RAI Volume 3, Chapter 2.2.1.3.1, Second Set, Number 3, Supplemental:

RAI: Volume 3, Chapter 2.2.1.3.3, First Set, Number 7, Supplemental:

RAI: Volume 3, Chapter 2.2.1.3.4, First Set, Number 3, Supplemental:

Figure 1. (a) Weight Loss Coupon Assembly from the LTCTF Illustrating Where the Spacers Were Located; (b) Optical Image of a Re-Cleaned Weight Loss Specimen Illustrating the Locally Dark Regions on the Specimen Surface

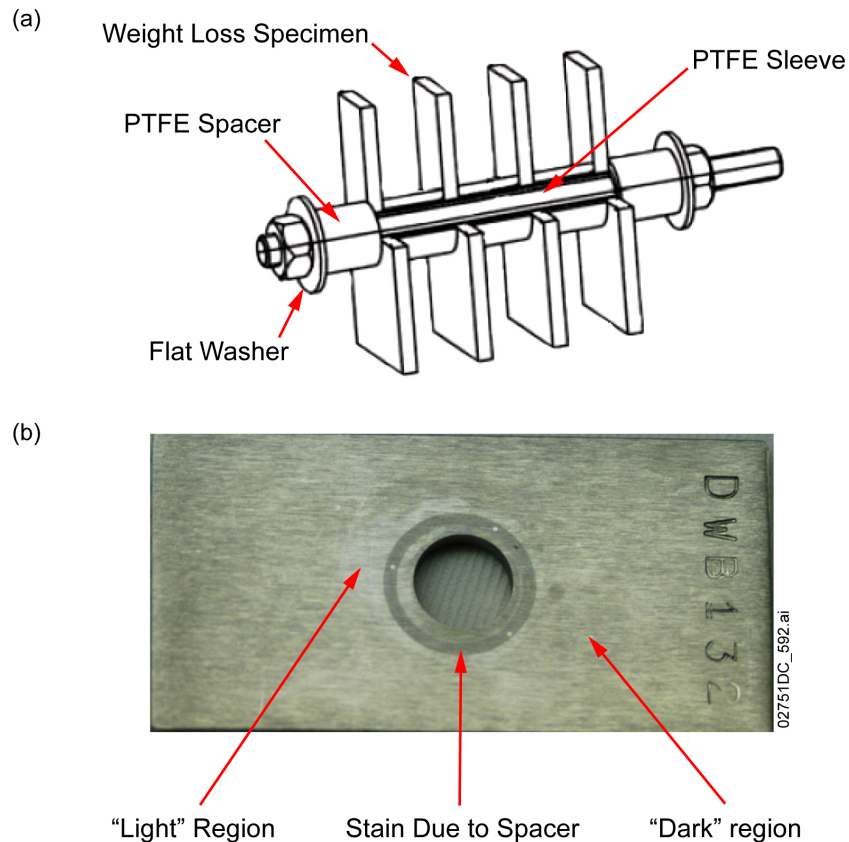
Explain whether or not the test conditions and unexpected results described in CRs 12799 and 12868 affected the samples and data used to derive corrosion rates discussed in SAR Section 2.3.6.3 and the recleaned specimens test data discussed in DOE's responses to RAIs 3.2.2.1.3.1-2-003 and 3.2.2.1.3.1-2-004. If the SAR and recleaned specimen data were affected by the test conditions described in the CRs, discuss the impact on the Performance Assessment.

1. Clarify the number of 5-year test specimens affected by the unexpected conditions described in CR 12799 and CR 12868.
2. Clarify if the assessment will include details for the 5-year corrosion rate data.
3. Clarify if there is any overlap between the oxide deposits identified in CR 12799 and carbon deposits in CR 12868.
4. Clarify if the cleaning procedures used in both CRs are consistent with cleaning procedures in DOE's response to Set 2, RAI #3.2.2.1.3.1-2-003.

While analyzing the surface of corrosion test coupons taken from the LTCTF after they had been cleaned, it was noted that the surface oxide appeared optically irregular, with both light and dark regions visible. These regions corresponded predominantly to the location where the polytetrafluoroethylene (PTFE) spacer used between coupons made contact with the coupon surface, and consisted of approximately 3% of the total surface area of each coupon (see Figure 1). The cleaning process utilized to prepare these coupons is described in the response to RAI 3.2.2.1.3.1-2-003, Section 1.2 (Specimen Re-Cleaning).

Corroborative, non-Q, secondary ion mass spectrometry (SIMS) analysis revealed a locally thicker oxide in the dark region corresponding to where the spacer had contacted the coupon (see Figure 1B). The oxide thickness in the regions below the PTFE spacer was evaluated on both 5- and 9.5-year specimens taken from the LTCTF, the results of which are summarized in Table 1.

Figure 1. Original FEHM Breakthrough Simulations and Recalculated T2R3D Simulations ($\gamma = 0.4$) with Instantaneous Pulse Release in Fractures at the Top of the Column, and Fluxes of 1, 3, 10, 30, and 100 mm/yr, Plotted with Uncalibrated Plug-Flow Points from NFC Model

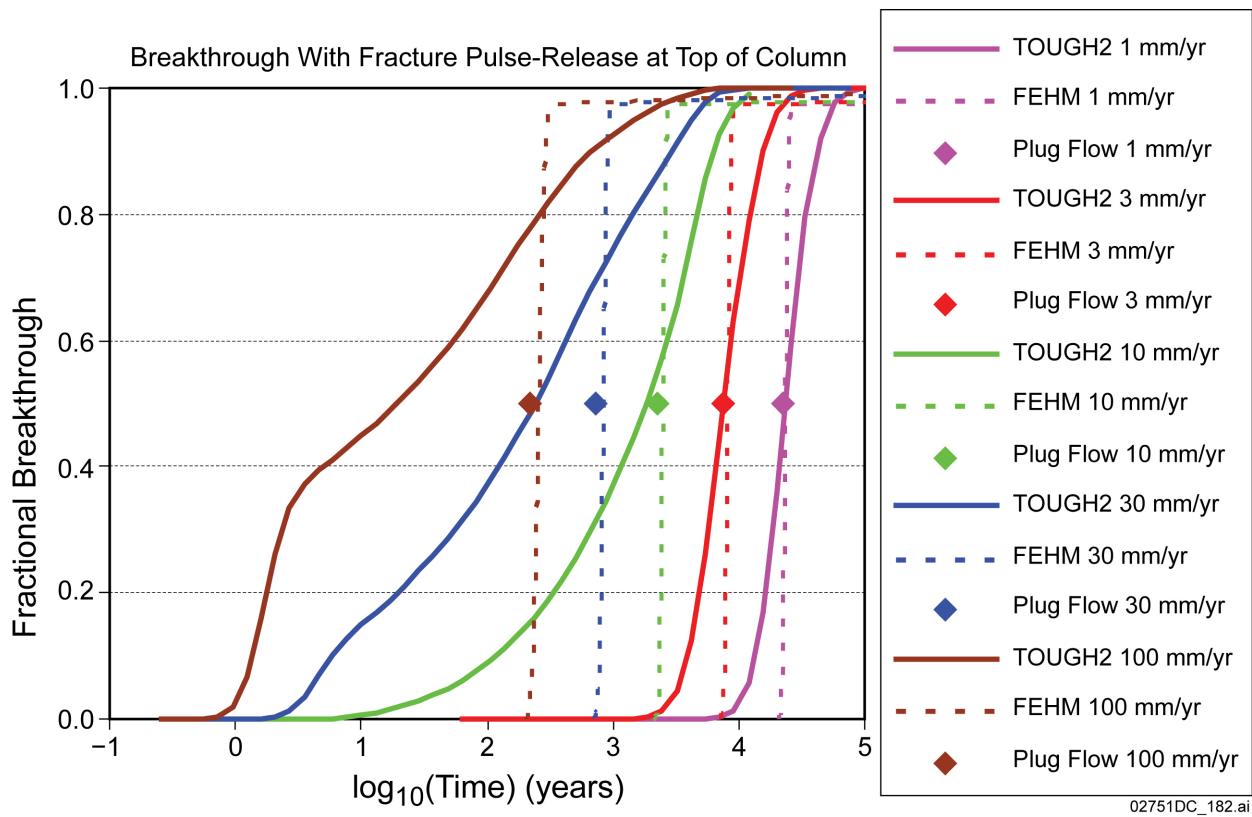
Transport in the NFC model is calculated using a plug flow approximation. Provide technical bases that demonstrate using average hydraulic properties in the NFC model appropriately captures the variability and uncertainty in seepage water compositions expected in the repository environment. Consider the impact of variable flow rates on potentially aggressive seepage water chemistry as influenced by water residence times and feldspar dissolution rates.

All of the simulations discussed here, including the original work supporting the NFC model, were generated for ranges of percolation flux from 1 to 100 mm/yr, thereby addressing the impact of variable flow rates. Trend extrapolation is used in the NFC model for limited application to percolation flux values greater than 100 mm/yr (SNL 2007a, Section 6.3.2.4.4). All of the simulations were performed with zero longitudinal and transverse dispersivities, which is appropriate given that matrix diffusion has a much greater effect on tracer transport than does dispersion.

As shown in Figure 1 and Table 4, breakthrough times for the T2R3D simulations are similar to the FEHM results up to a percolation flux of approximately 10 mm/yr, and then decrease relative to the FEHM results for flux greater than 10 mm/yr. The breakthrough curves in Figure 1 are distributions of tracer residence time for the boundary condition of instantaneous fracture release (pulse, top of column). “Tailing” of the breakthrough curves increases for simulations at higher flux values. This dispersive “tailing” is caused mostly by the retarding effect of matrix diffusion. Residence time dispersion is not important to the use of calculated average or median residence times from these curves because fracture-matrix interaction is a spatially and temporally continuous process. The effect of matrix diffusion on the composition of seepage water is, therefore, represented by a convolution of breakthrough curves such as those presented here, with a continuous source function. The result is mixing of the effects from the upper and lower tails of the residence time distributions, in a manner that produces a net result that can be represented by an average or median residence time.
